Planning Commission
Council Chambers
February 15, 2022 – 6:00 p.m.
233 South Main Street, Monroe, Ohio

CITY OF MONROE
Inter-Office Correspondence

DATE: February 15, 2022
RE: Information Packet for February 15, 2022 Planning Commission Meeting at 6:00 p.m.

I. Case No. 2022-2-3— Consideration of Site Plan Application for Brooks 63 Retail Plaza

C-3.1

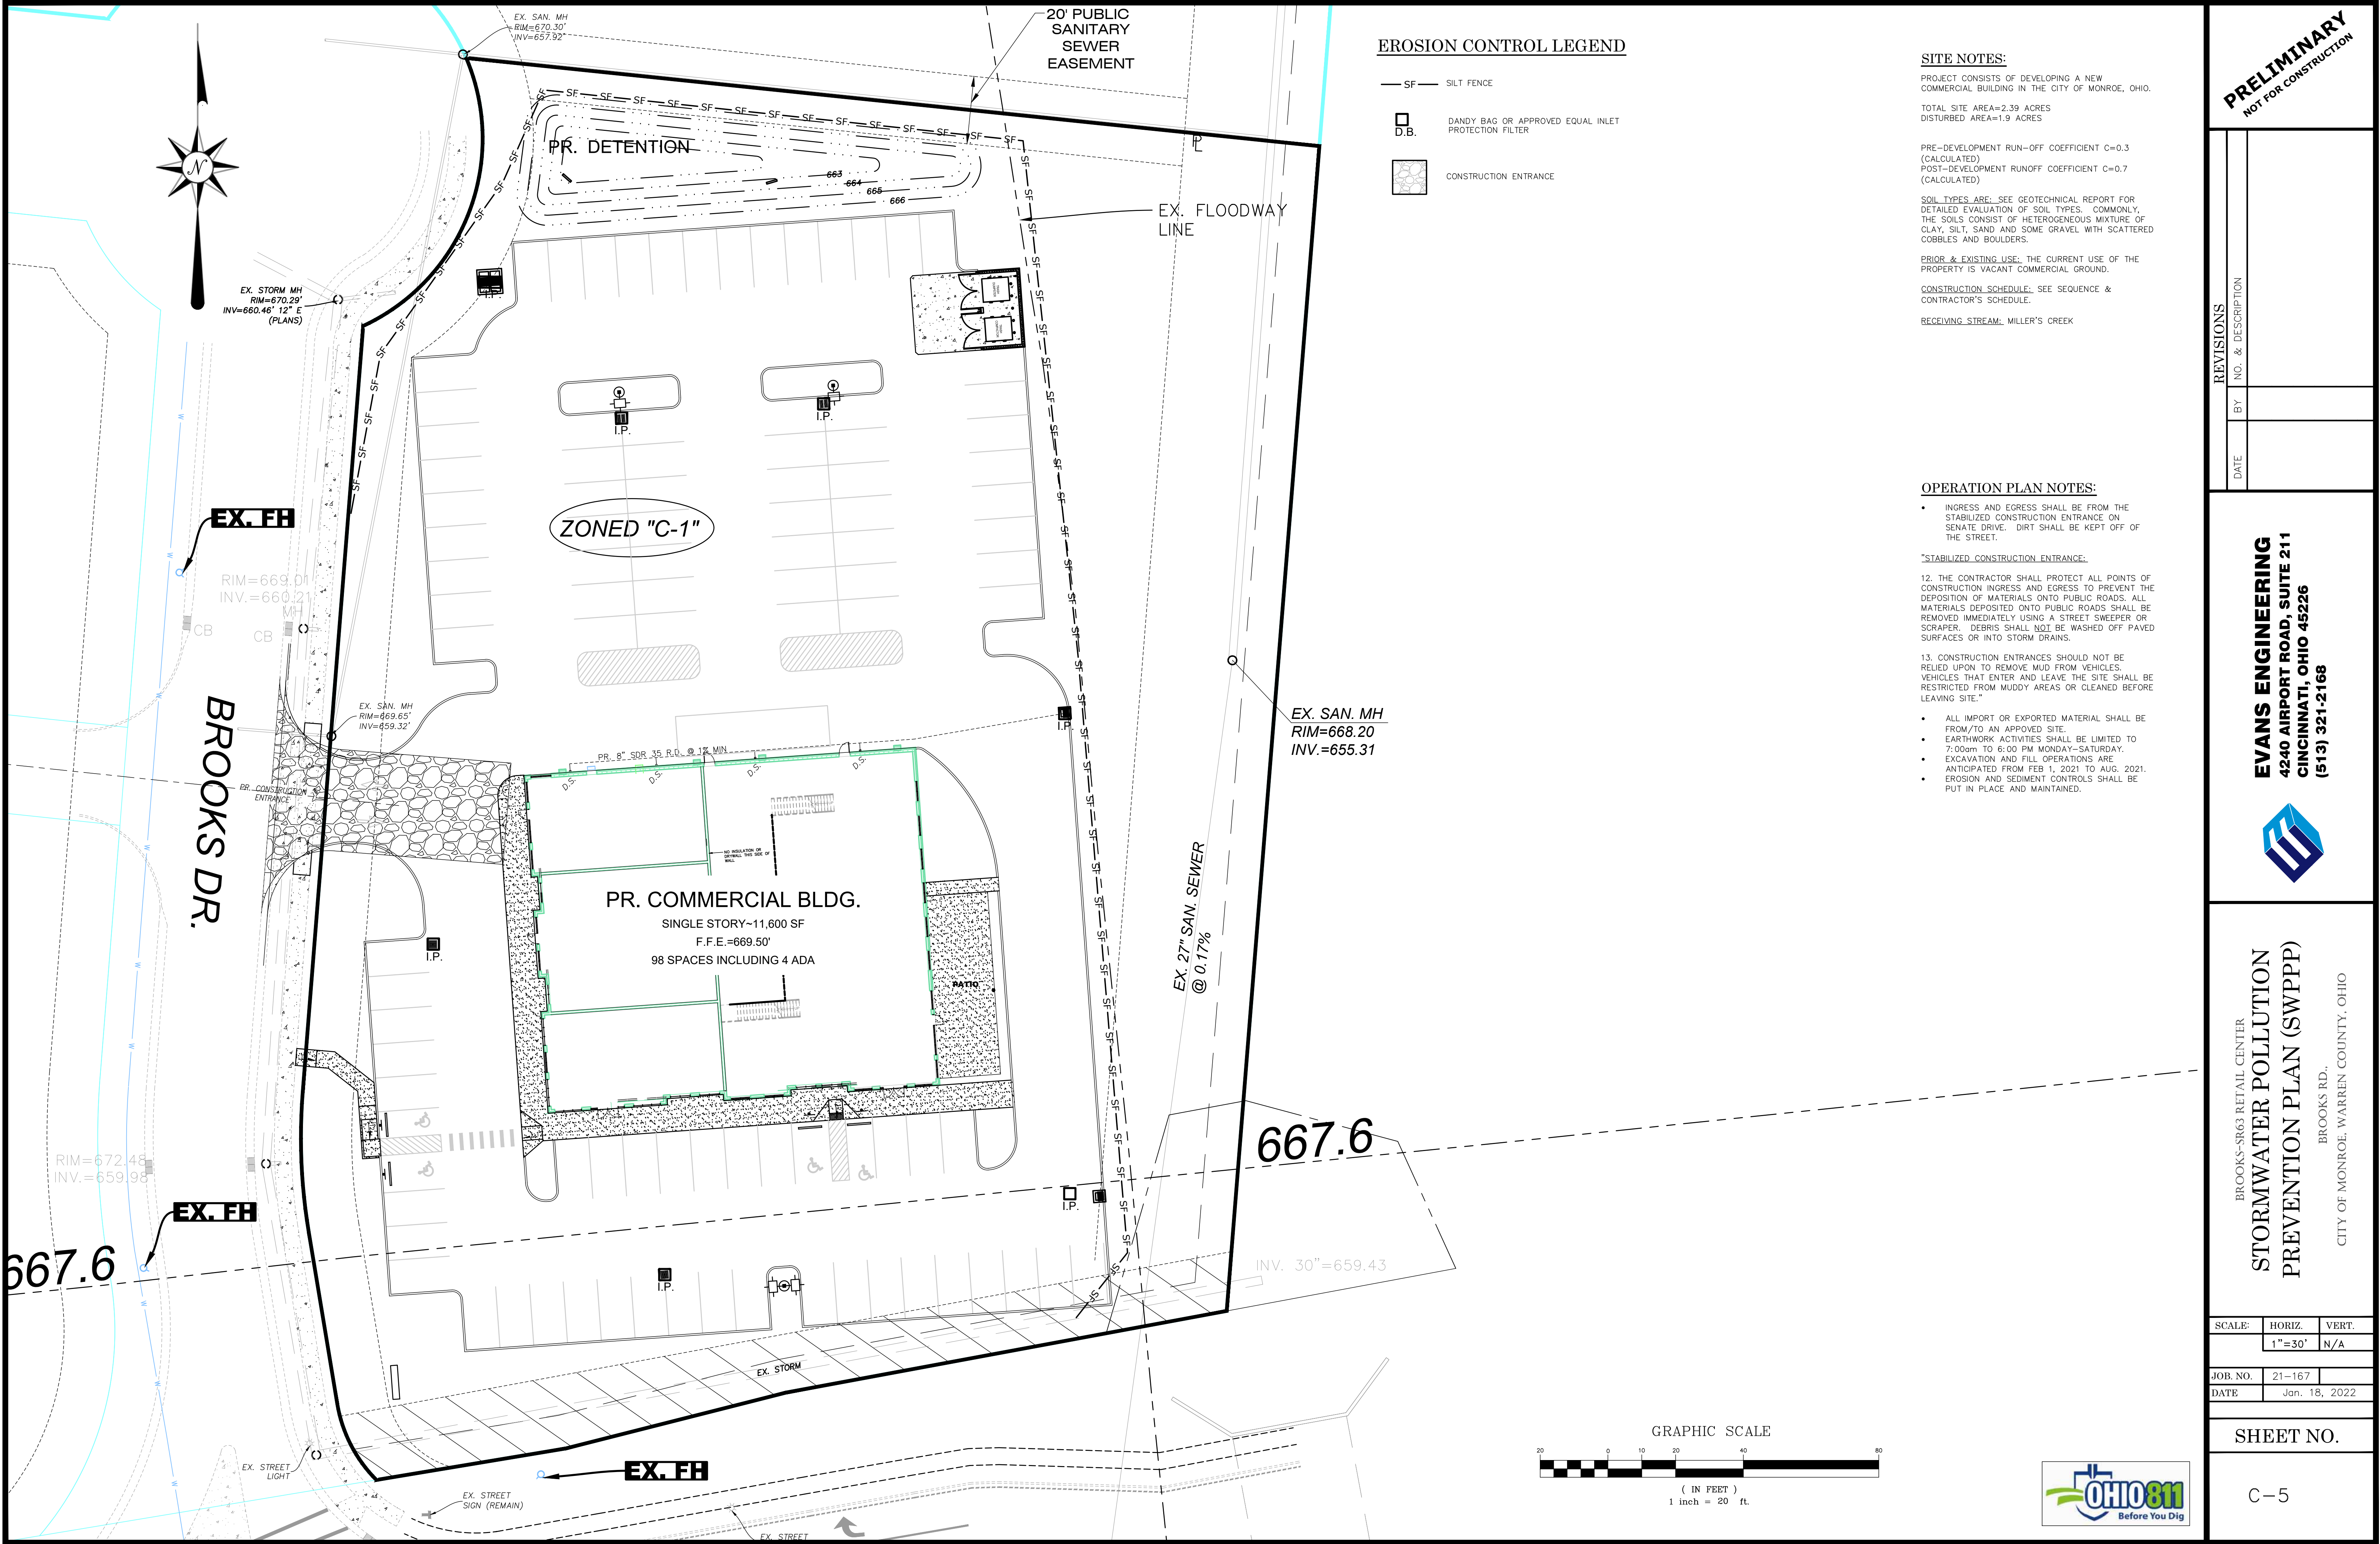
- **C-3.1:**
 - Appears to be missing utilities in SR 63 RoW.
 - Show walk in SR 63 as being constructed.
 - Revise commercial driveway to meet City specifications.

- **Fishbeck Comment No. 7** – On Sheet C-3 and 3.1, it appears that CB-3A is on the easement line for the 27-inch sanitary sewer along the east side of the site. Verify that it is outside of the easement.

- **Fishbeck Comment No. 8** – On Sheet C-3.1, for the proposed catch basin 3A (6), the elevation for the outlet pipe invert cannot be read because it is under the property boundary line. The text should be moved so that the elevation can be clearly seen.

- **Fishbeck Comment No. 9** – The top elevations of the outlet control structure in plan on sheet C-3.1 and Sheet C-4 need to match those shown on the detail on Sheet C-4.
